ATTN: Document Control Desk
U. S. Nuclear Regulatory Commission
Washington, DC 20555-0001**SUBJECT:****Beaver Valley Power Station, Unit No. 2
Docket No. 50-412, License No. NPF-73
Supplemental Information for Beaver Valley Power Station Unit 2 Spent Fuel Pool
Rerack License Amendment Request (TAC No. ME1079)**

Response to September 27, 2010 NRC Request for Supplemental Information

Response to September 27, 2010 NRC Request for Supplemental Information
Page 1 of 49

Figure 17-1: Strain Rate Amplification Curve for Base Metal Material

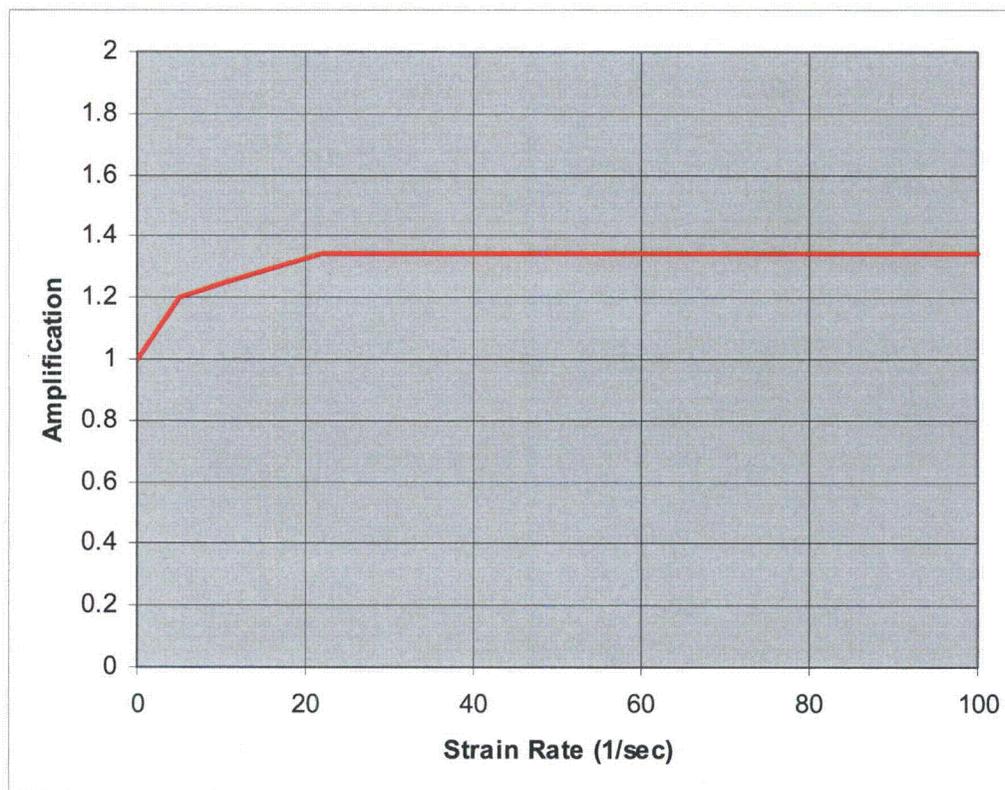
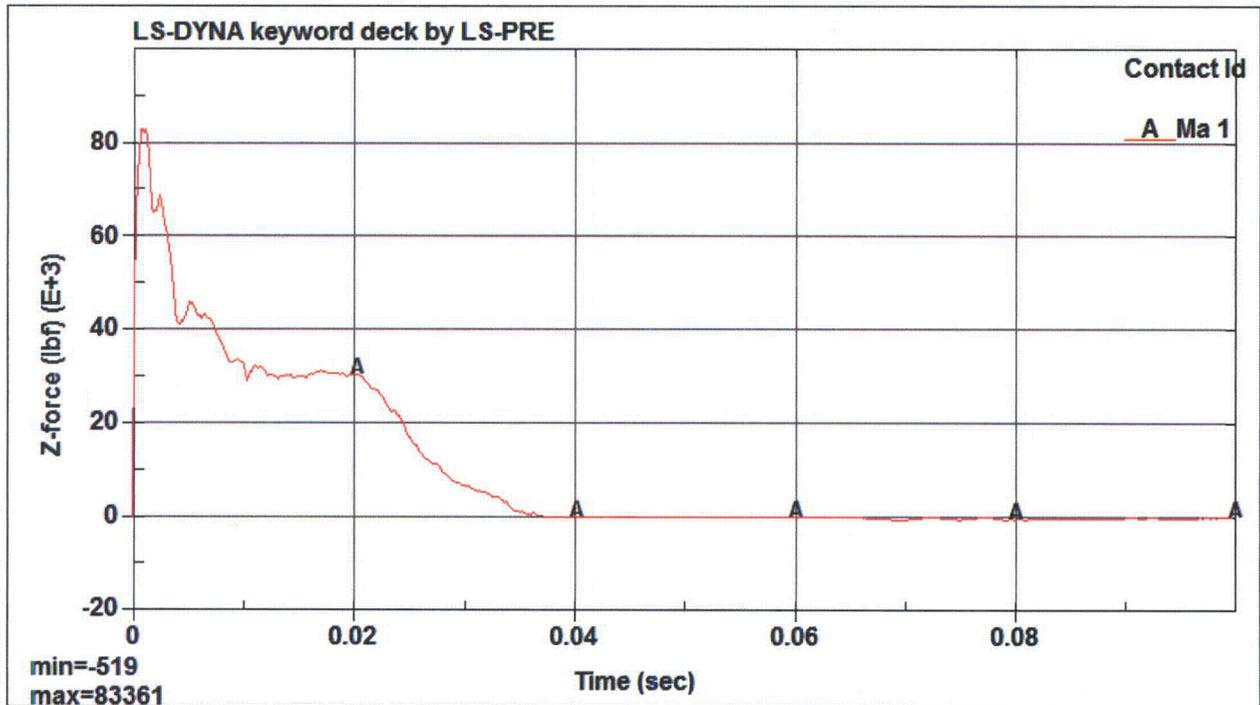
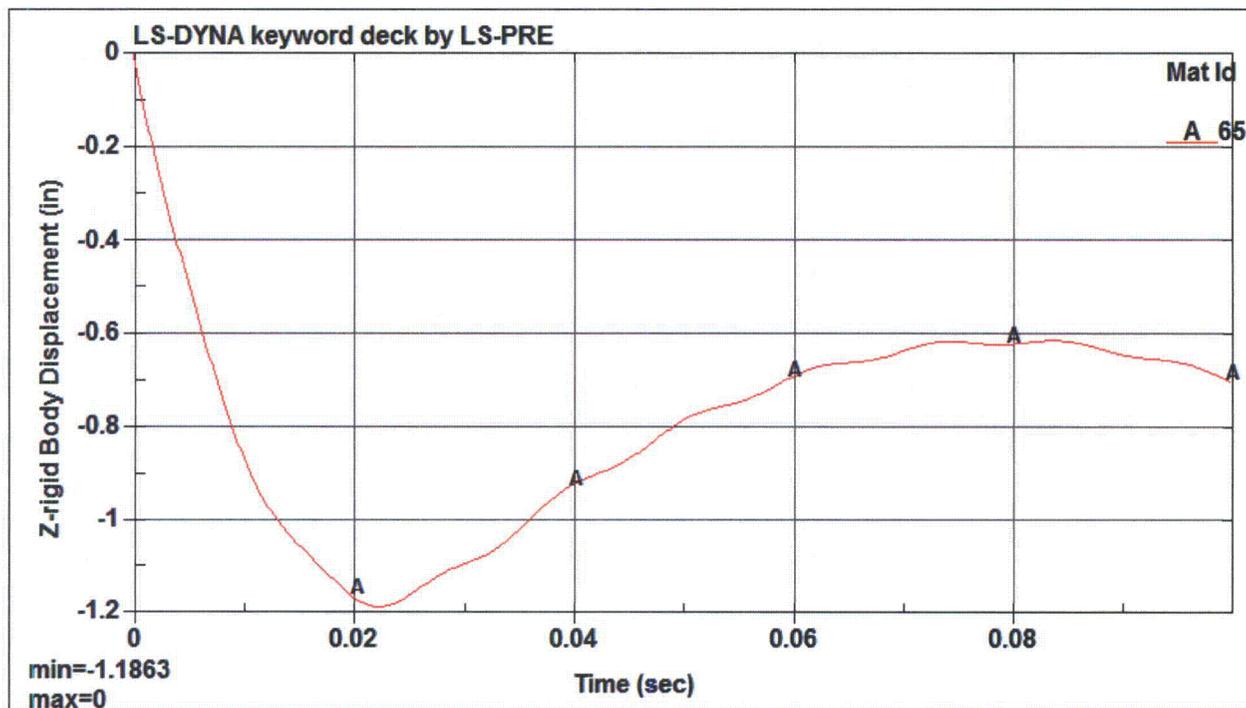
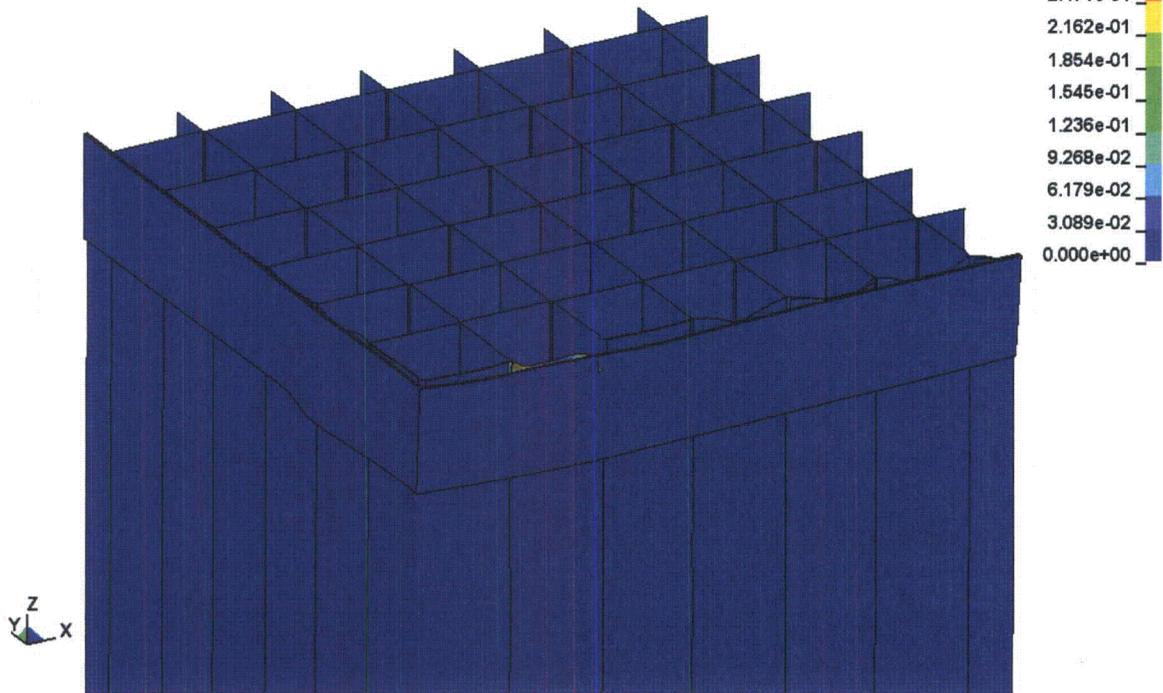
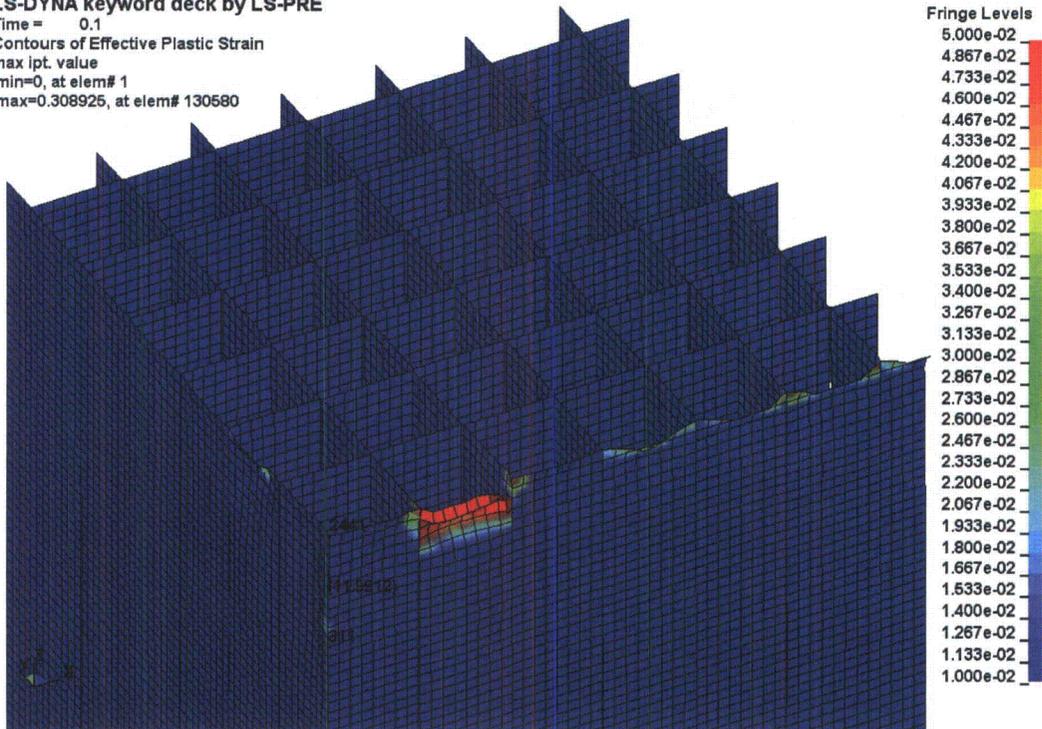
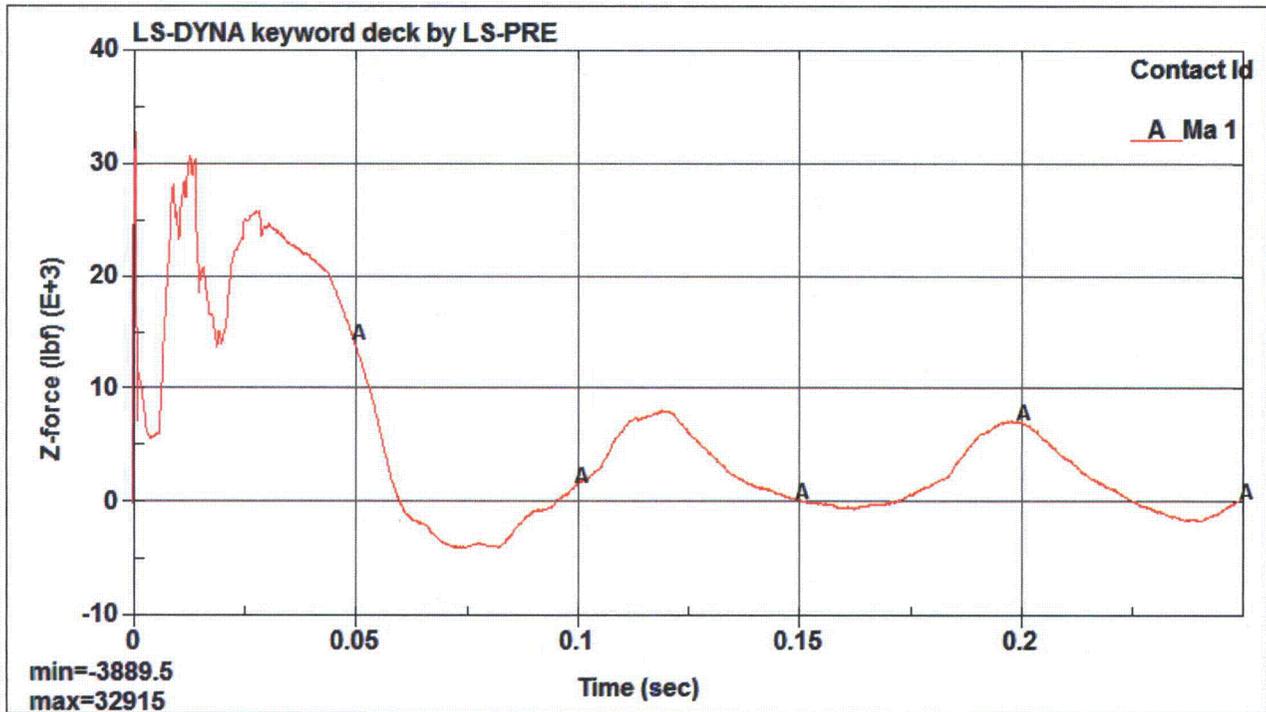
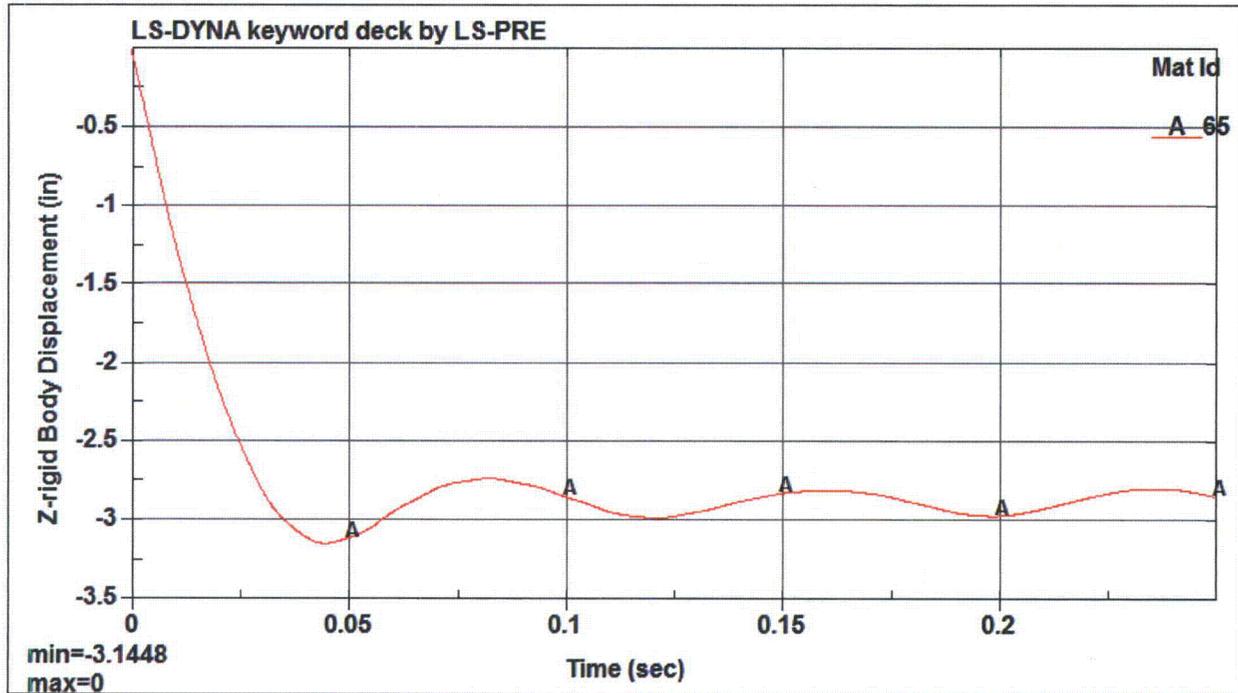
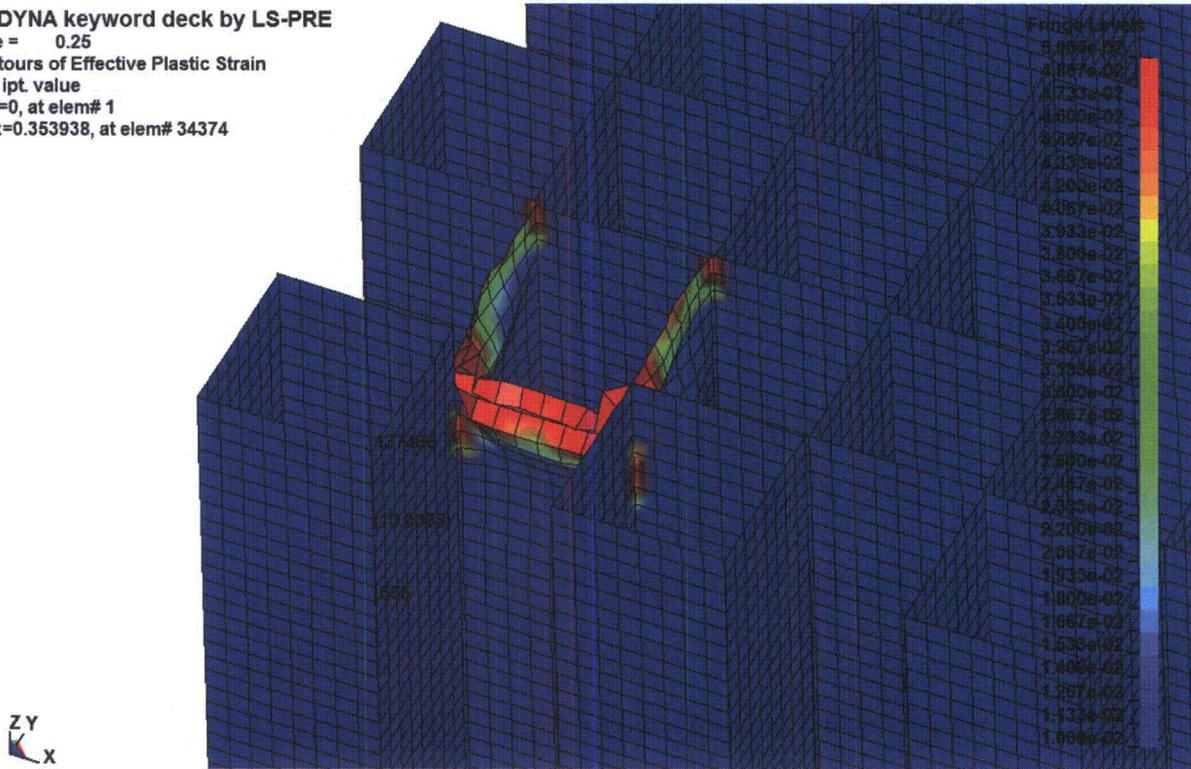
2. Document the basis for using the INL paper for determining the strain rate amplification curve for the weld material. Additionally, the supplemental information will document the discussion regarding RAI 17 to provide explicit details regarding the material model curve which was used in the LS-DYNA analysis. This will include information relative to where the strain rate amplification was applied (i.e., only the stress was increased) and where the triaxiality factor was applied to provide a clear understanding of what the value for the true failure is for the shallow-drop accident analysis. Coupled with this discussion, justification regarding the strain amplification value(s) used and at what point during the analysis these values are used will be provided. This justification should focus on how the amplification factor is applied to the true stress-strain curve in the LS-DYNA model, i.e. describing whether an iterative procedure is used in LS-DYNA to capture the strain rate value and then apply the corresponding amplification factor or whether a constant strain rate amplification factor is applied to the true stress-strain curve.

In the previous analysis, the Idaho National Laboratory *Impact Testing of Stainless Steel Material at Room and Elevated Temperatures* (INL) paper was used to determine the strain rate amplification curve for the weld material based on the similar chemical compositions of SA-240 304L base metal and Type 308 weld material. The shallow drop analysis has been re-performed using the strain rate amplification data from the INL paper for the base metal material only. No strain rate amplification factors are applied to the weld material. The following paragraph describes the material model curves for the base metal and the weld material in more detail, including the precise

The strain rate amplification curve applied to the base metal material, which is based on the INL paper, is shown in Figure 17-1. Throughout the simulation, the strain rate amplification factor for each base metal element is determined based on the instantaneous strain rate of the element (that is, an iterative procedure is used). The time-dependent and element-dependent amplification factors are applied only to the stress values in the true stress-strain curve for the base metal material.

The results for the fuel assembly drop onto a perimeter cell are shown in Figures 17-2 through 17-4, and summarized in Table 17-2. The results for the fuel assembly drop onto an interior cell are shown in Figures 17-5 through 17-7, and summarized in Table 17-3.

The LS-DYNA analysis results demonstrate that the plastic deformation in the rack cell walls resulting from a shallow drop accident (onto a perimeter cell or an interior cell) does not extend down into the neutron absorber zone, which is defined as the vertical length of the cell blanketed by the fixed neutron absorber panel. For the BVPS-2 spent fuel racks, the minimum distance from the top of the rack to the top edge of the neutron absorber panel (the neutron absorber zone) is 19.75 inches. From the LS-DYNA simulations, the dropped fuel assembly moves downward crushing the impacted cell wall to a maximum depth of 3.15 inches (interior cell drop), and the plastic strain in the impacted cell wall diminishes to zero at a distance of 12 inches (perimeter cell drop) below the top of the rack (Figure 17-4). Since the depth of damage by either measure is less than 19.75 inches, the neutron absorber panels do not suffer any damage, and therefore the shallow drop accident has no adverse effect on the criticality safety analysis for the BVPS-2 spent fuel racks. In fact, the criticality safety analysis takes no credit for the uppermost 1.3 inches of neutron absorber length, which extends above the active fuel region (assuming the maximum active fuel height and worst-case tolerances). Therefore, taking into consideration the criticality safety analysis, the more precise limit on the permanent deformation to the spent fuel rack due to a shallow drop accident is no greater than 21.05 inches (19.75 inches plus 1.3 inches) measured from the top of the rack. Based on this criterion, the minimum computed safety factor for the shallow drop accident is:
